DEFINITIVE SUBDIVISION PLAN FOR COLTON ROAD EXTENSION

Definitive Subdivision Plan for Colton Road Extension
Post-Construction
Long Term Stormwater Operation & Maintenance Plan-Revision 1
August 10, 2020

**RE: *Response to Planning Director Questions, Comments
And Recommendations, July 16, 2020
Definitive Subdivision Plan Pre-Application Review 2
Colton Road Extension
7 Colton Road – Millbury, MA
ADE Job #3085.00***

RE: *Response to Engineering Peer Review Comments, July 13, 2020*
Colton Road Extension
7 Colton Road – Millbury, MA
ADE Job #3085.00

ROAD PLAN AND PROFILE STA 8+50 TO 17+50
FOR
COLTON ROAD EXTENSION
MILLBURY, MASSACHUSETTS
JUNE 10, 2020

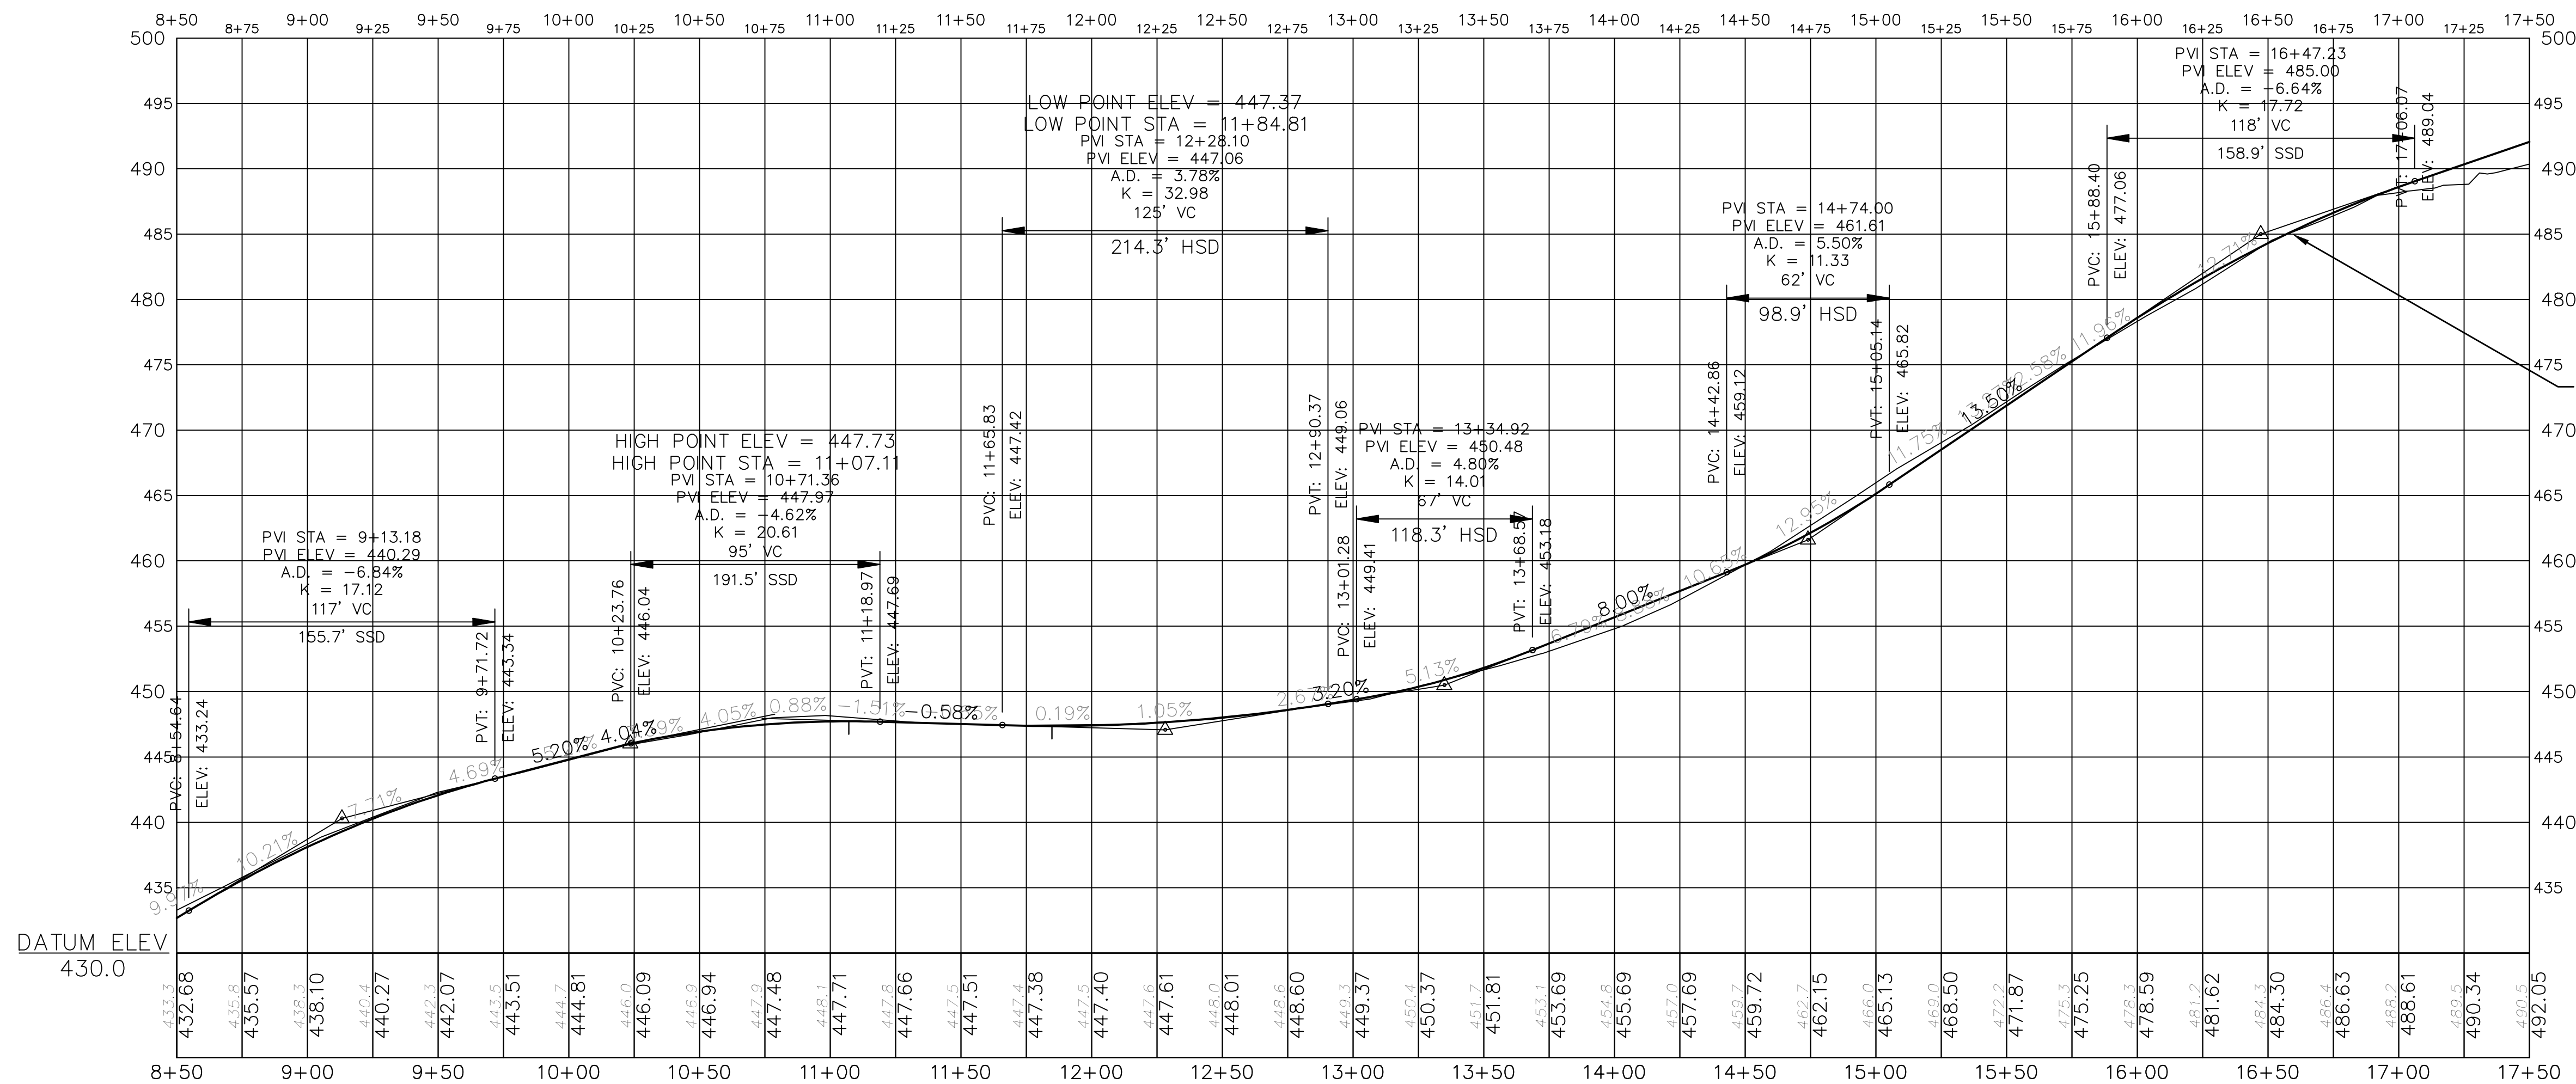
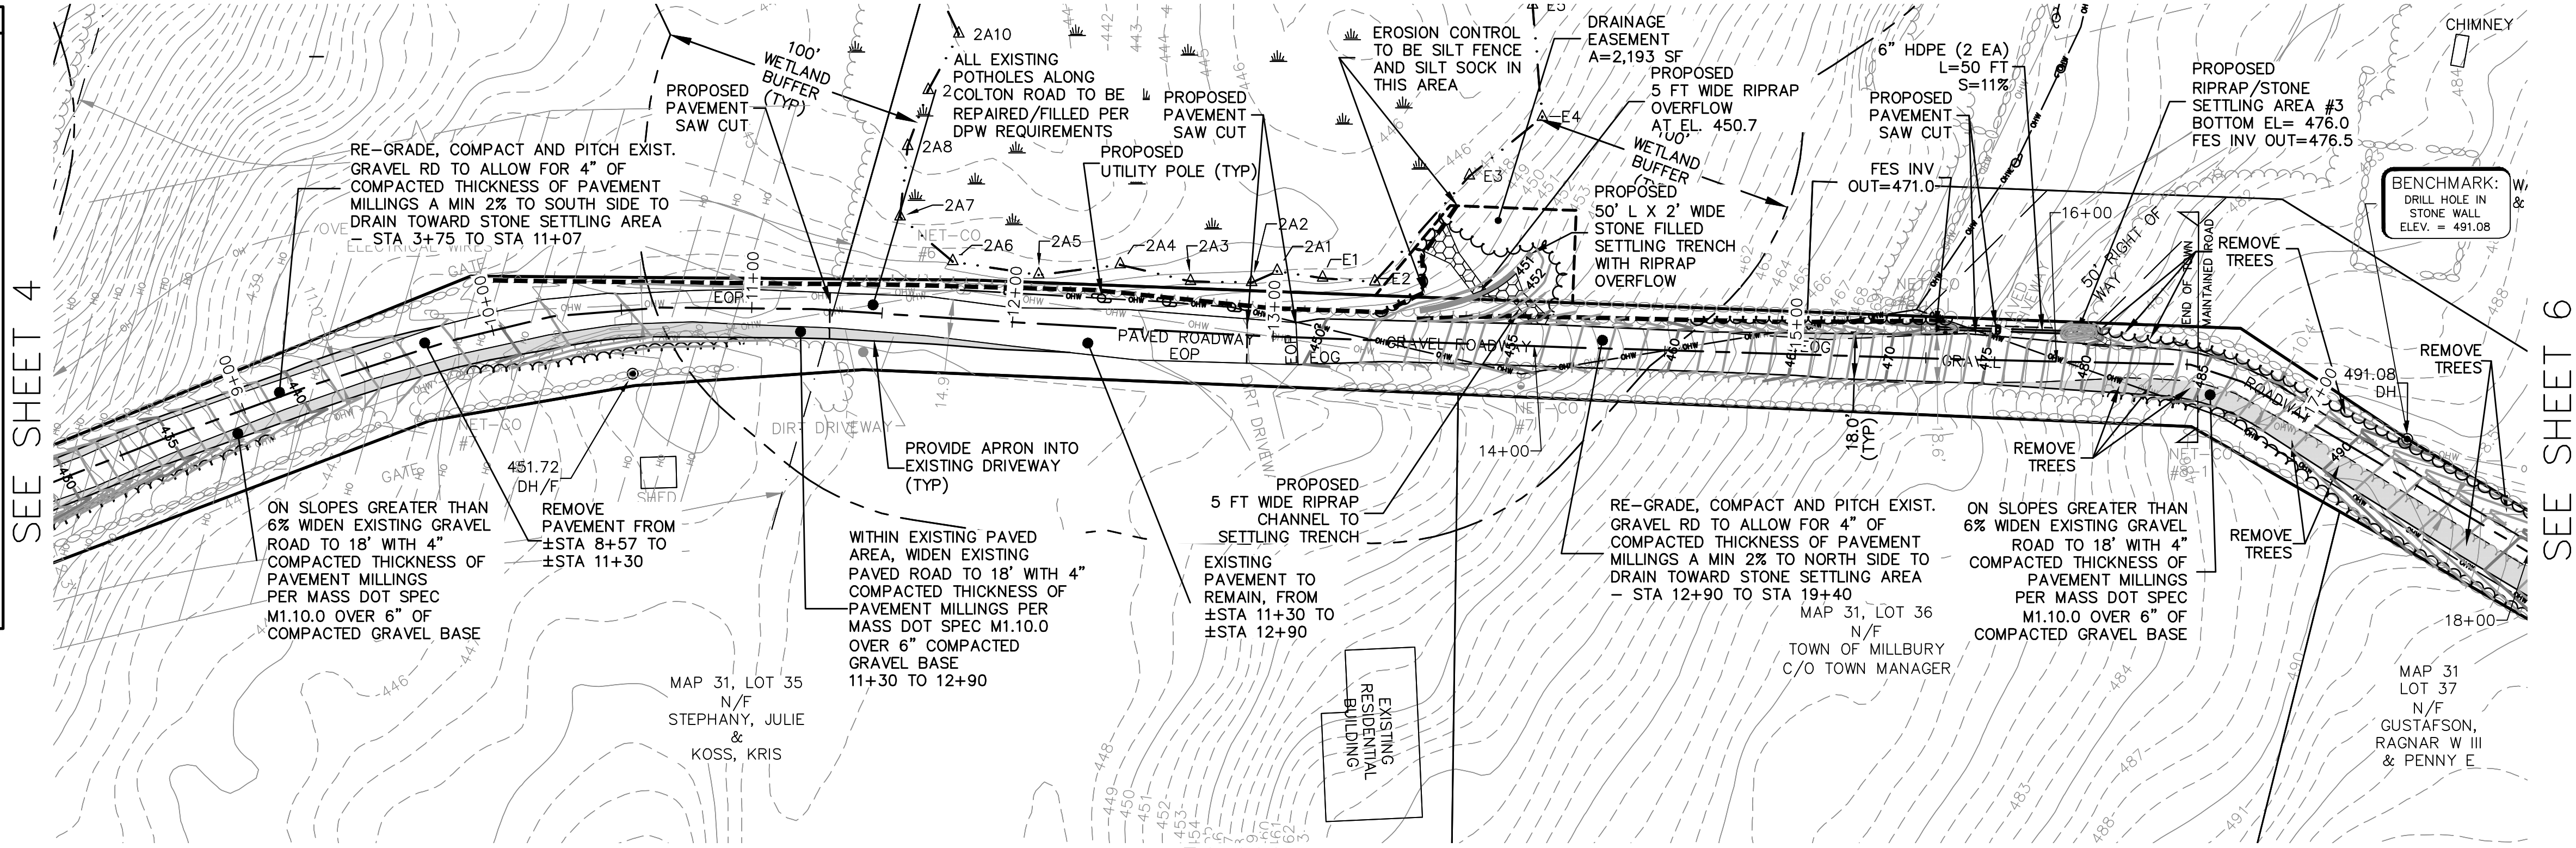
We recommend proposed erosion and sedimentation controls be identified on plan and profile sheets 4, 5 and 6 associated with “Colton Road”.

ADE Response: Sediment controls are identified on sheets 4, 5 and 6 and are indicated with a dashed linetype. Sediment controls are located down gradient of the proposed work.
